RE: **Case No. SD2026-0003:**
The owner, Shaunta Bernal, represented by Mason & Associates requests approval of the Bernal Landing Subdivision preliminary plat, a two-lot subdivision on Parcel R30550012. The parcel, approximately 5.3 acres, is zoned "R-R" (Rural Residential). The subject "Property" is located at 7218 Airport Road, Nampa, also referenced as a portion of the NE ¼ of Section 20, T3N, R1W, BM, Canyon County, Idaho.

Applicant: Mason & Associates	Case Number: SD2026-0003
Subdivision Name: Bernal Landing Sub.	Plat Date: 4/23/2026 (2 nd Rev.)
Planning Review	
Scale of Drawing (No more than 1" = 100' unless approved by DSD before submission. Size of Drawing (No larger than 24' x 36"). <i>Obtain an electronic version of all submittals.</i> (CCZO 07-17-09(1)A).	
Review Comment: Compliant. 1"= 40'	
Proposed name of the subdivision and its location by section, township, and range (CCZO 07-17-09(1)B.1).	
Review Comment: Not compliant. Should be SW ¼, NE ¼, Section 20 2 nd Rev: Compliant.	
Name, address, and phone number of the developer (CCZO 07-17-09(1)B.3).	
Review Comment: Compliant.	
Name, address, and phone number of the person preparing the plat (CCZO 07-17-09(1)B.4).	
Re

**BERNAL LANDING
EXISTING FEATURES/ NO BUILD AREAS**

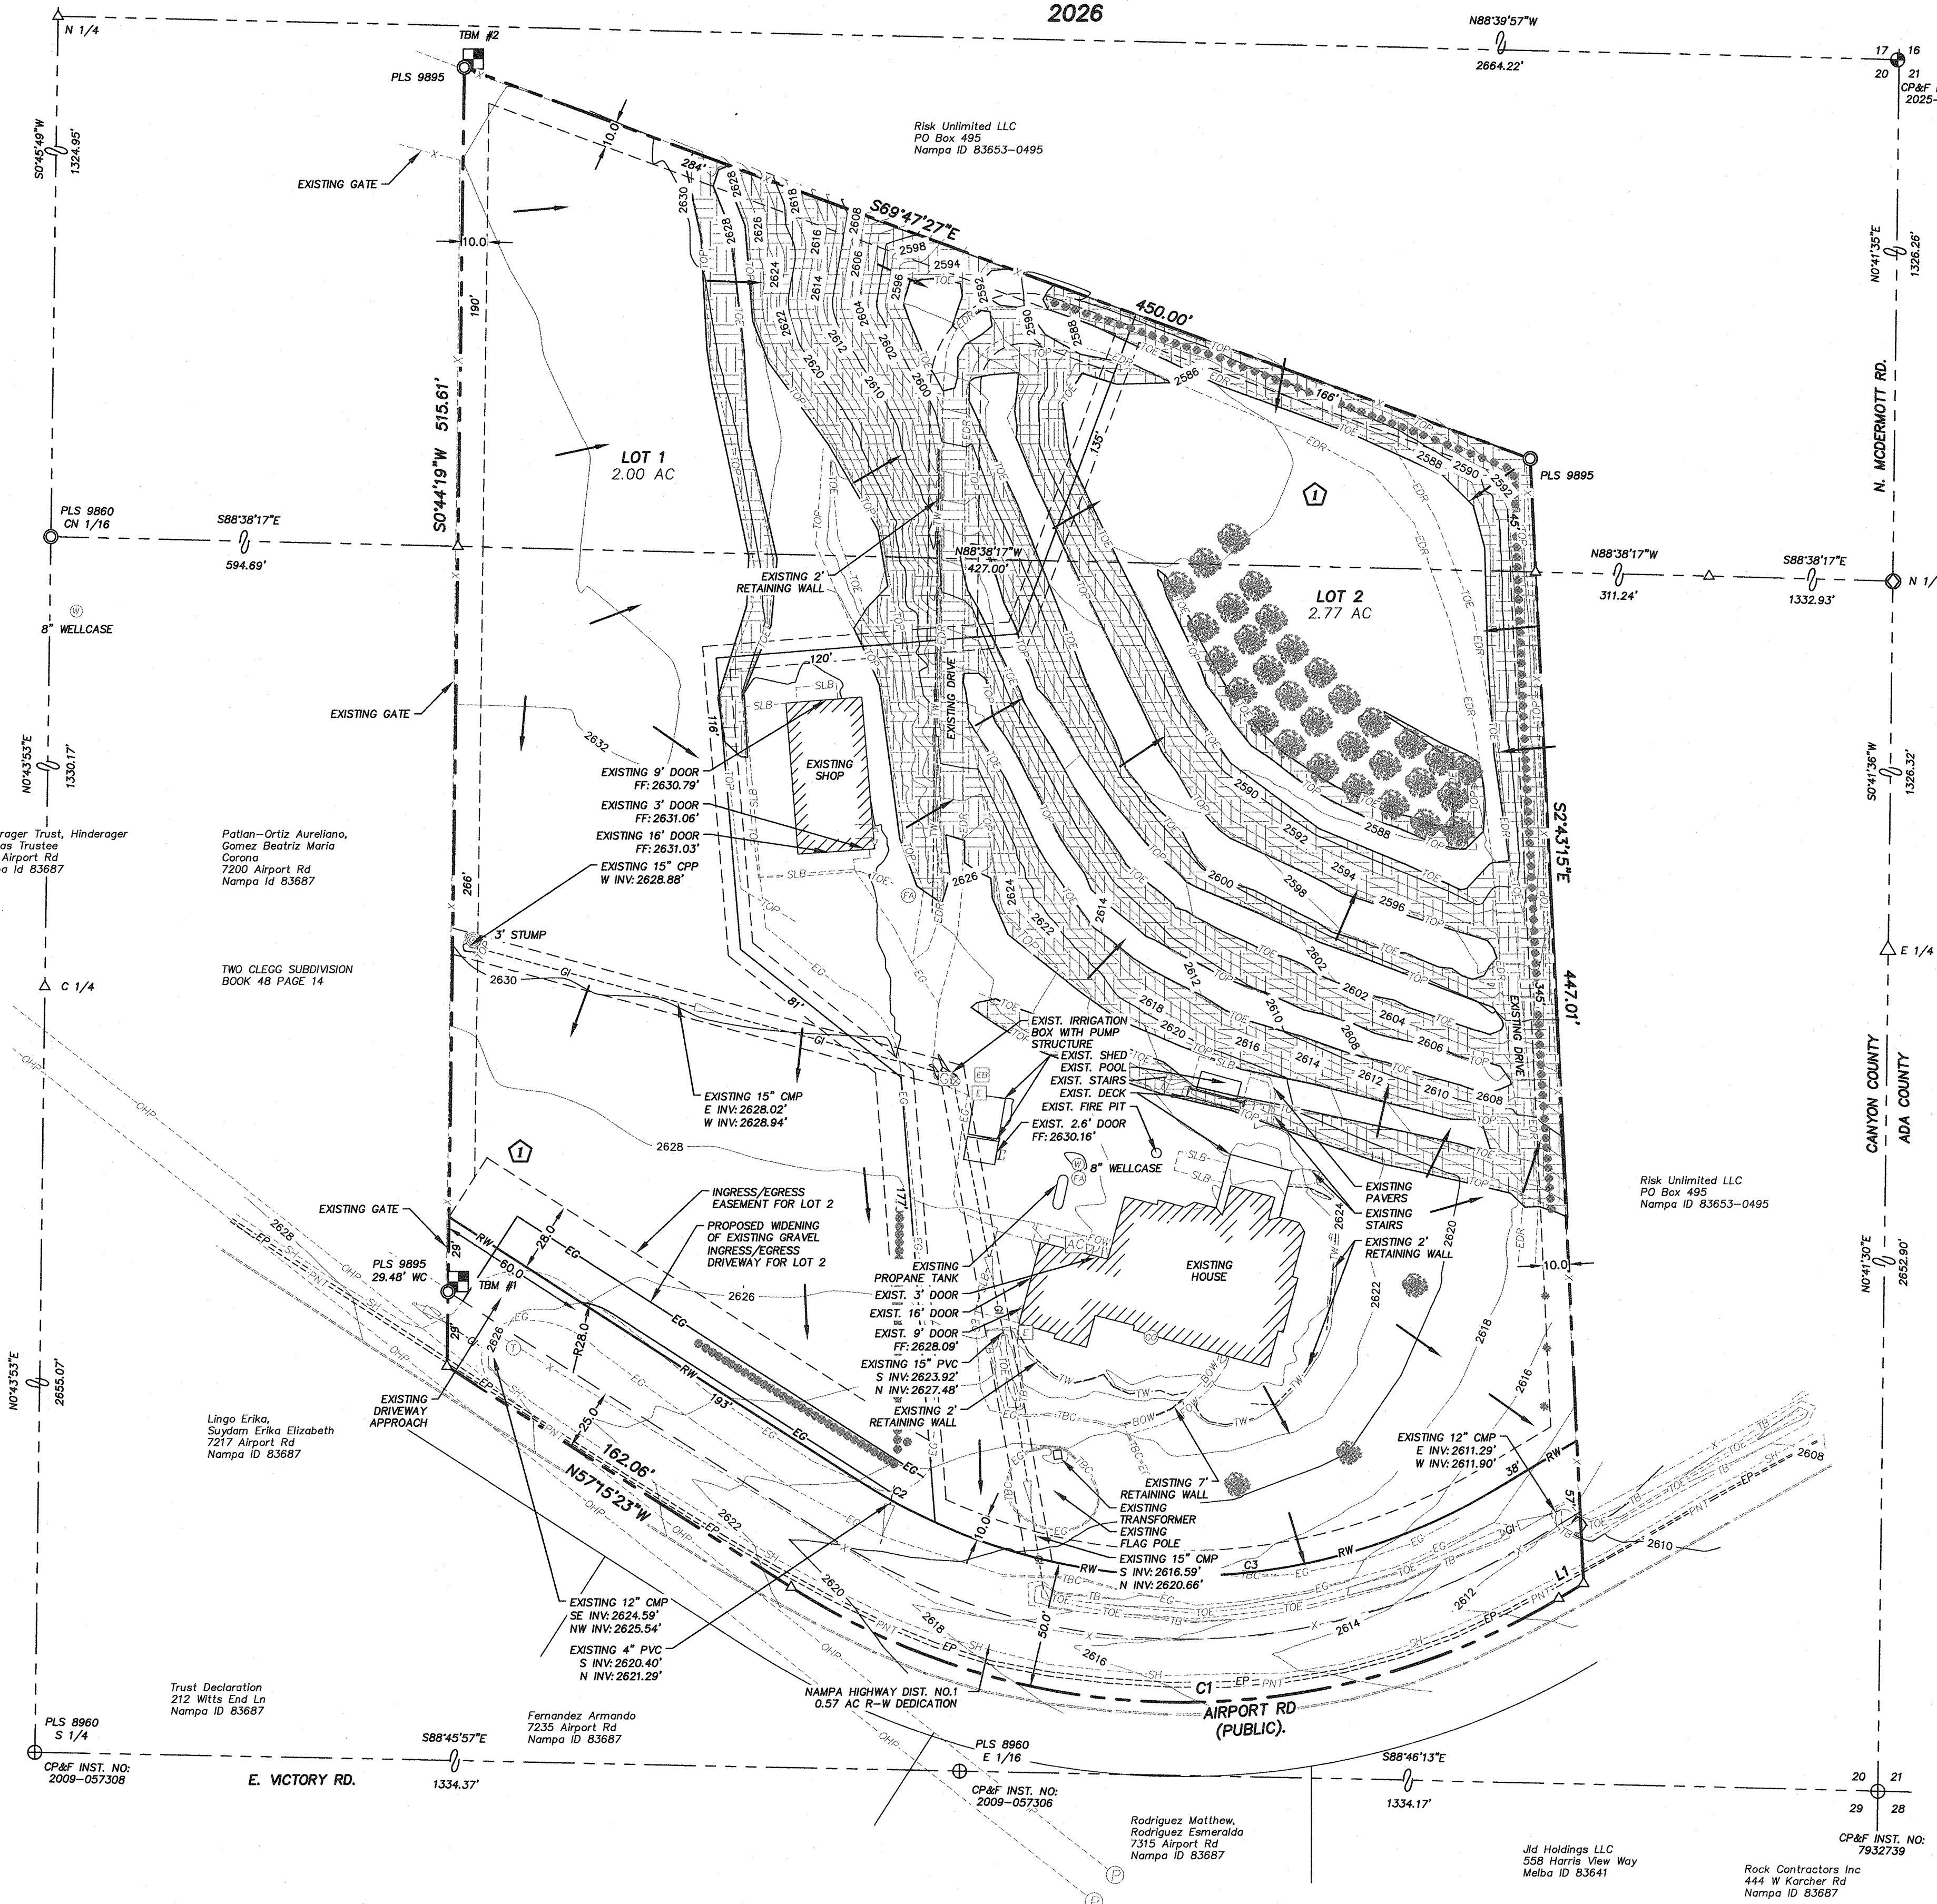
Engineering Review
Existing Conditions: Two-foot contours are shown unless otherwise approved; show all areas in excess of 15% slope (CCZO 07-17-09(1)C.1).
<u>Review Comment:</u> While contouring appears to be shown on the plan, the submitted application indicates that no lots contain slopes greater than 15%; however, the east portion of the property appears to have been previously disturbed/graded and should be evaluated more closely. Please provide more information. 2 nd review: Compliant. The preliminary plat (Sheet 2) includes crosshatch shading to designate non-buildable areas with slopes 15% on the northern/eastern portion of the property.

Existing Conditions: Location of water wells, streams, canals, irrigation laterals, private ditches, washes, lakes, or other water features; direction of flow; location and extent of known areas subject to inundation (CCZO 07-17-09(1)C.2).
<i>Review Comment: Please revise the plans to more clearly identify all existing water features, including irrigation facilities, swales/drainage paths, and flow direction. The submitted materials reference existing gravity irrigation and note that stormwater historically flows through swales, but the plans should more clearly label these features and indicate drainage direction for the record. If there are no streams, canals, or inundation areas on site, please note that on the plans. The property is served by Nampa & Meridian Irrigation District, and stormwater/access water flows through swales and is filtered through vegetation.</i> 2nd review: Compliant.

<i>Review Comment: The preliminary plat appears to show two lots and lot labels; however, please confirm that all lot dimensions and any required curvilinear data are clearly shown and legible on the face of the plat.</i> 2nd Review: Curve C3 is labeled on the plat, but the curve table only includes C1 and C2. Please fix.
Location, width, and use of easements (CCZO 07-17-09(1)D.3).
<i>Review Comment: Please clearly identify all easements on the preliminary plat, including shared driveway access/ingress-egress easements, utility easements, irrigation easements, and any drainage/stormwater easements, as applicable. The submitted packet includes draft Water Users Agreement and Driveway Users Agreement documents, which support shared irrigation and access, but the corresponding easement locations, widths, and purposes should be clearly reflected on the plat.</i> 2nd review: Compliant Utility easements must also be shown graphically. Please fix.

Review Comment: The submittal states that excess stormwater has historically been retained on site and continues to flow through swales, with filtration through vegetation. Please add a clear statement on the plans describing the proposed stormwater management approach and confirm that stormwater will be retained on site, if that is the intent. Also identify any existing or proposed roadside swales, their function, and any protection/maintenance responsibilities. If any swales or facilities are treated to runoff from public roads, maintenance easements may be required. Additional detail may be needed to demonstrate that the proposed lot split will not adversely affect existing drainage patterns.

- Clarify and label all drainage paths, swales, and flow directions.
- Verify whether any areas exceed a 15% slope and provide additional hillside/grading information if required.

- Clearly show all easements and confirm their widths and uses, including shared driveway, irrigation, utility, and drainage easements.
- Provide adequate irrigation supply and distribution documentation for both lots.
- Confirm whether driveway widening or other access improvements will be required for Lot 2 and show those improvements on the plans, if applicable. The letter of explanation states that the existing driveway will need to be widened when the future right-of-way is taken.

- **Correction of the two-lot/three-lot inconsistency.**
- **Shared driveway and Fire District approvals prior to building permit issuances. See condition #12 below.**
- **Missing C3 curve data. Provide revised plat.**
- **Complete easement and public dedication information.**
- **Water Users Agreement. See Condition #9 below**

3. Airport Road labeled as a public road.
4. The northern portion of the property exhibits graded slopes exceeding 15%, which are attributable to historical use as an agricultural drainage pond used for field drainage. Following the subdivision and sale of this parcel from the original holding, the basin was decommissioned. The sloped area has since been intentionally re-contoured to enhance aesthetic appeal and create garden areas. The work was shallow and intended only for gardening, avoiding deep disturbance and did not alter drainage patterns. There is no known history of mineral extraction here.

7. Per the Engineering Review, hatching was added to show slopes greater than 15%. The northern portion of the property exhibits graded slopes exceeding 15%, which are attributable to historical use as an agricultural drainage pond used for field drainage. Following the subdivision and sale of this parcel from the original holding, the basin was decommissioned. The sloped area has since been intentionally re-contoured to enhance aesthetic appeal and create garden areas. The work was shallow and intended only for gardening, avoiding deep disturbance and did not alter drainage patterns. There is no known history of mineral extraction here.

8. Plans revised to enhance visibility of all existing water features and direction of water flow on parcel.
9. Lot lines and curves are labeled.
10. Nampa Highway District right-of-way to be dedicated as shown.

11. Stormwater runoff on the private drive will be conveyed as historically has been through a vegetated swale. All storm water will be retained on site as historically has been through vegetation and existing berming in locations along property line. The lot split will not affect the current drainage patterns.
